| Name of Project | Franklin Hills Estates & Country Club | CGP Tracking No. | IR #20-10 | Inspection Date | 1/27-28/2021 |
| Present Phase of Construction | Phase 1 | | | | |
| Inspection Location (if multiple inspections are required, specify location where this inspection is being conducted) | Areas of Concern as defined at site walk with wetlands commission | | | | |

Photo 1: Stone check dam immediately upgradient of main entry water crossing has been repaired.

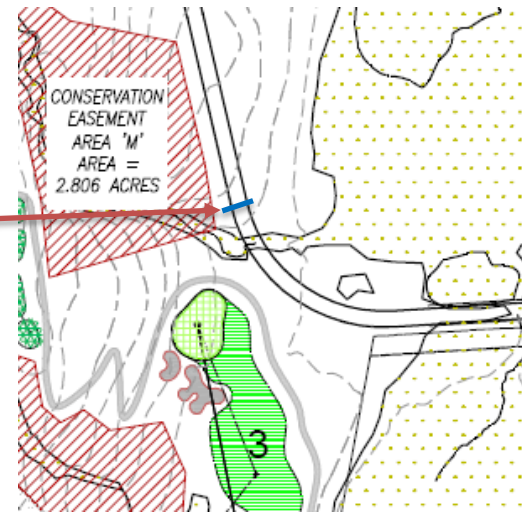
| Type/Location of E&S Control | Repairs or Other Maintenance Needed?* | Corrective Action Required?* | Date on Which Maintenance or Corrective Action First Identified? | Notes |
|--|---|---|--|--|
| 1. Main Entry Water Crossing (Northerly of 3 rd Hole Green) | <input type="checkbox"/> Yes <input checked="" type="checkbox"/> No | <input type="checkbox"/> Yes <input checked="" type="checkbox"/> No | | Stone check dam immediately upgradient of crossing has been replaced and has ample storage capacity (Photo 1). Stone check dam in trail leading down to crossing has been replaced and has ample storage capacity (Photo 2). An additional check dam has been added. |

Photo 3: Sediment fence has been repaired and reinforced with stone check dams.

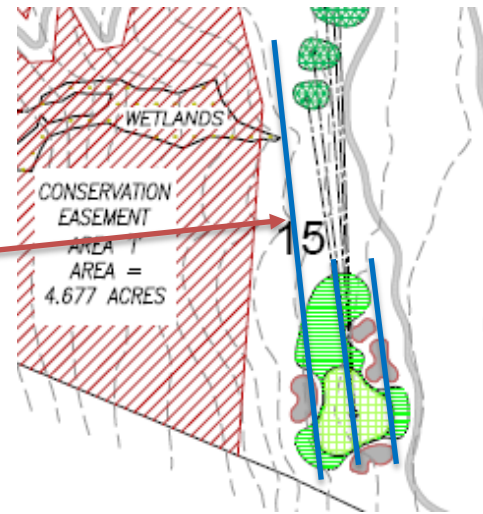
| Type/Location of E&S Control | Repairs or Other Maintenance Needed?* | Corrective Action Required?* | Date on Which Maintenance or Corrective Action First Identified? | Notes |
|--|---|---|--|--|
| 2. 15 th Green Sediment Barriers | <input type="checkbox"/> Yes <input checked="" type="checkbox"/> No | <input type="checkbox"/> Yes <input checked="" type="checkbox"/> No | | Downgradient stone check dam remains in good condition. Sediment fence along the cart path and along the tree line have been repaired and reinforced with stone check dams. Intermediate sediment fence has been re-staked. (Photo 3). Sediment fence rows and staked hay bales in south end have been repaired and eroded area has been stabilized with stone. (Photo 4). |

Photo 5: Stone check dams and staked hay bales are in good condition. Sediment fence has been repaired and an additional stone check dam has been added.

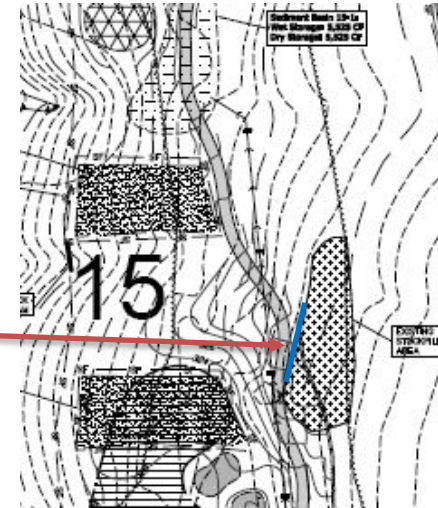
| Type/Location of E&S Control | Repairs or Other Maintenance Needed?* | Corrective Action Required?* | Date on Which Maintenance or Corrective Action First Identified? | Notes |
|--|---|---|--|--|
| 3. 15 th Fairway Sediment Barriers | <input type="checkbox"/> Yes <input checked="" type="checkbox"/> No | <input type="checkbox"/> Yes <input checked="" type="checkbox"/> No | | Stone check dams, stone apron are in good condition and functioning as intended. Sediment fence has been repaired and reinforced with additional stone check dam (Photo 5). |

Photo 6: Recently constructed swale carrying flow to downgradient drainage structure. No signs of erosion in swale.

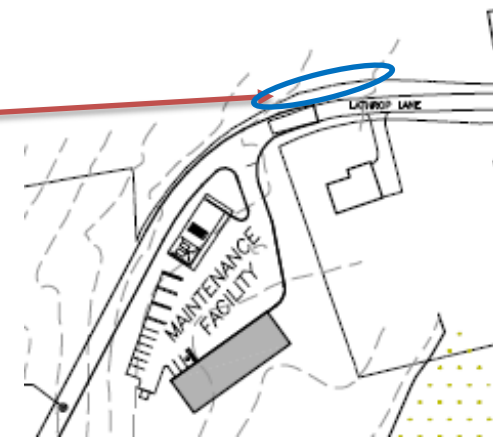
| Type/Location of E&S Control | Repairs or Other Maintenance Needed?* | Corrective Action Required?* | Date on Which Maintenance or Corrective Action First Identified? | Notes |
|--|---|---|--|--|
| 4. Construction Entrance (Westerly of Proposed Maintenance Road) | <input type="checkbox"/> Yes <input checked="" type="checkbox"/> No | <input type="checkbox"/> Yes <input checked="" type="checkbox"/> No | | Stone check dam and water bar across construction entrance are in good condition and functioning. Staked hay bales and sediment fence are deteriorating and have been removed from flow path (Photo 6). Diversion swale excavated to downgradient drainage structure does not show signs of erosion. Stone check dams should be added to new swale if erosion occurs. |

| Stabilization Area | Stabilization Method | Have You Initiated Stabilization? | Notes |
|--|---|--|---|
| 1. Construction Access Drive | Plans - Anti-tracking pad Existing - Water bar at site entrance | <input checked="" type="checkbox"/> Yes <input type="checkbox"/> No <input type="checkbox"/> N/A | There was little flow in the swale during the inspection with no evidence of erosion. Add stone check dams to swale if erosion occurs. |

Photo 7: Stone check dams across the 7th hole fairway hillside remain in good condition. Sediment fence rows and hay bales have been repaired and reinforced with stone check dams.

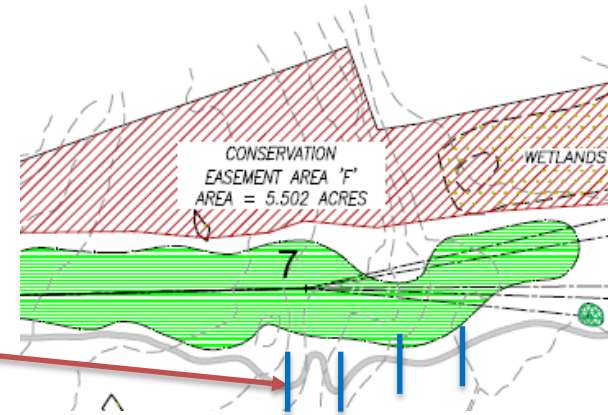
| Type/Location of E&S Control | Repairs or Other Maintenance Needed?* | Corrective Action Required?* | Date on Which Maintenance or Corrective Action First Identified? | Notes |
|--|---|---|--|--|
| 5. 7 th Hole Fairway Hillside | <input type="checkbox"/> Yes <input checked="" type="checkbox"/> No | <input type="checkbox"/> Yes <input checked="" type="checkbox"/> No | | Check dams across 7 th Hole fairway are in good condition overall and functioning as intended (Photo 7). Sediment fence has been repaired and reinforced with additional stone check dams. |

| Stabilization Area | Stabilization Method | Have You Initiated Stabilization? | Notes |
|--|---|--|---|
| 2. 7 th Hole Fairway Hillside | Plans – Multiple rows of silt fence Existing – Series of stone check dams and silt fence | <input checked="" type="checkbox"/> Yes <input type="checkbox"/> No <input type="checkbox"/> N/A | Area is stabilized at this time. Stone check dams are in good condition. Sediment fence rows and staked hay bales have been repaired and reinforced with stone check dams. |

Photo 8: Sediment fence row across 11th hole tee box area has been repaired and stone check dam upgraded. A hay bale check dam has been added upgradient of the sediment fence.

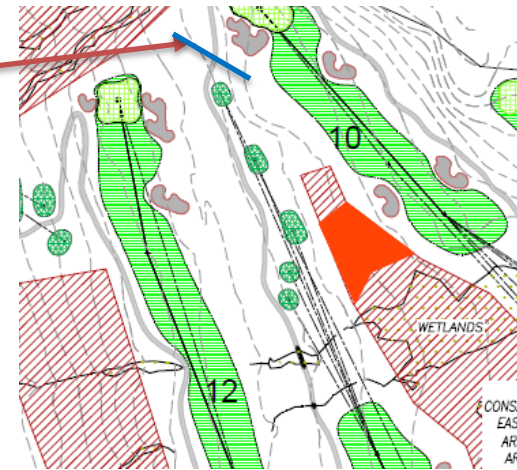
| Type/Location of E&S Control | Repairs or Other Maintenance Needed?* | Corrective Action Required?* | Date on Which Maintenance or Corrective Action First Identified? | Notes |
|--|---|---|--|--|
| 6. 11 th Hole Tee Box Area | <input type="checkbox"/> Yes <input checked="" type="checkbox"/> No | <input type="checkbox"/> Yes <input checked="" type="checkbox"/> No | | Sediment fence row across path by 11 th Hole tee box has been repaired and reinforced with an additional hay bale check dam (Photo 8). Stone check dam has been replaced. |

| Stabilization Area | Stabilization Method | Have You Initiated Stabilization? | Notes |
|--|---|--|---|
| 4. 11 th Hole Tee Box Area | Plans – Silt fence and diversion channel Existing – Single row of silt fence across path and one stone check dam | <input checked="" type="checkbox"/> Yes <input type="checkbox"/> No <input type="checkbox"/> N/A | Sediment fence has been repaired and reinforced with a hay bale check dam. An additional stone check dam has been added. |

Photo 9: Sediment fence has been repaired and additional stone check dams added to disrupt flows.

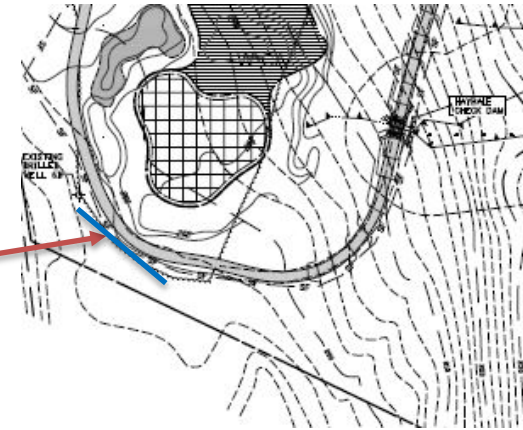
| Type/Location of E&S Control | Repairs or Other Maintenance Needed?* | Corrective Action Required?* | Date on Which Maintenance or Corrective Action First Identified? | Notes |
|--|---|---|--|--|
| 7. 14 th Hole Green Sediment Barriers | <input type="checkbox"/> Yes <input checked="" type="checkbox"/> No | <input type="checkbox"/> Yes <input checked="" type="checkbox"/> No | | Sediment fence row at tree line has been reinforced with an additional check dam (Photo 9). Additional stone check dams have been added upgradient of the sediment fence. |
